ENGINEERING PRACTICE STUDY

PROJECT NUMBER: 5961-2016-029

MIL-STD-750-4, TEST METHOD 4011:
PROPOSED REVISION TO CLARIFY THE TESTING PROCEDURES,
ADDRESS AUTOMATIC TEST EQUIPMENT AND REFORMAT CONTENT

FINAL REPORT

FIGURE 4011–1. Test circuit for forward voltage.

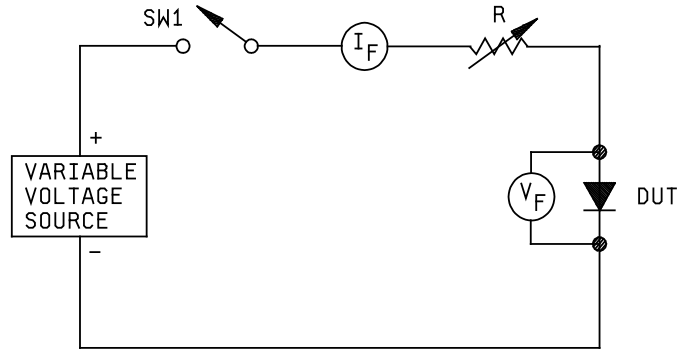
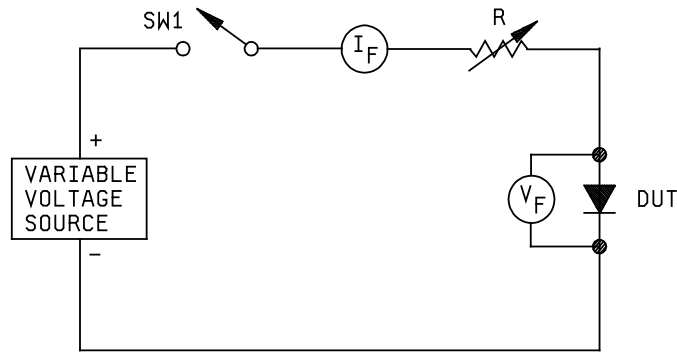
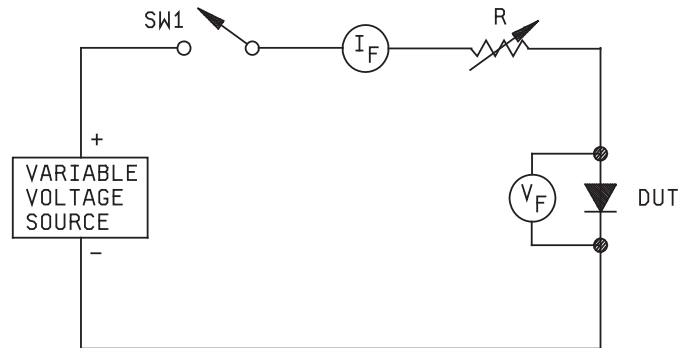
4.1.2 Electronic switch or pulse generator. When specified, switch SW1 as shown in the test circuit (see figure 4011–1) shall consist of either an electronic switch or a pulse generator to provide pulses of short-duty cycle to minimize device heating.

~~NOTE: When specified, switch SW1 shall consist of either an electronic switch or a pulse generator to provide pulses of short-duty cycle to minimize device heating. When pulse techniques are used, suitable peak-reading methods shall be used to measure the parameters of pulse amplitude, frequency, duty cycle, and pulse width. When dc techniques are used, device thermal equilibrium shall be achieved before the measurement is made.~~

4.1.2 Electronic switch or pulse generator. When specified, switch SW1 as shown in the test circuit (see figure 4011–1) shall consist of either an electronic switch or a pulse generator to provide pulses of short-duty cycle to minimize device heating.
